Subject: **FCC Class II Permission Change Request for FCC ID: VPYCMABZ**

This is to request a Class II Permission Change Request for FCC ID: VPYCMABZ, originally granted on 2017/02/08.

Top view without shielding

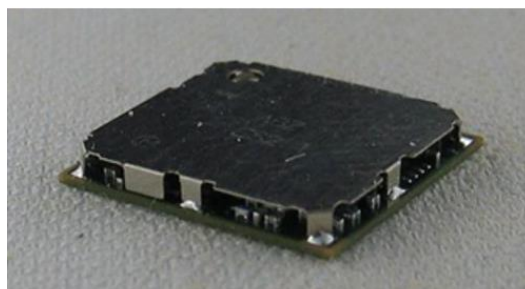
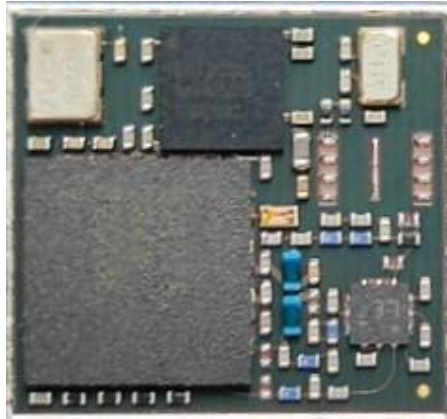
1. File a 32.768KHz crystal (Y1) substitution EPSON X1A000061001800 to the original model TXC 9H03200028.
2. File a 32MHz TCXO (Y2) substitution KDS 7EE03200A05 to the original model EPSON TG-5035CG-09N.
3. Adjust the component placement slightly to adopt a full-wrap metal shielding case.

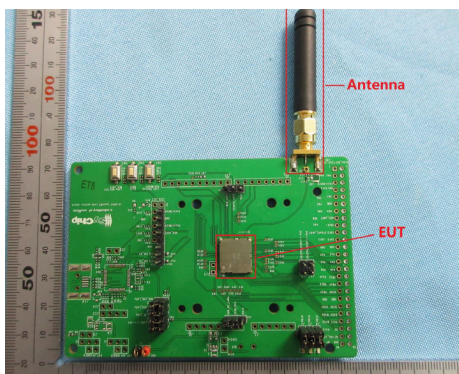
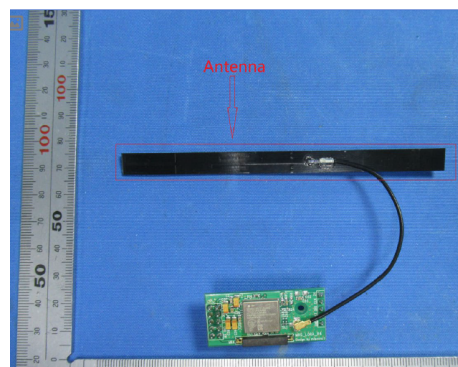
3. File an additional antenna (P/N: TE-LTFR-225, vendor: WINIZEN, peak gain: 2dBi).
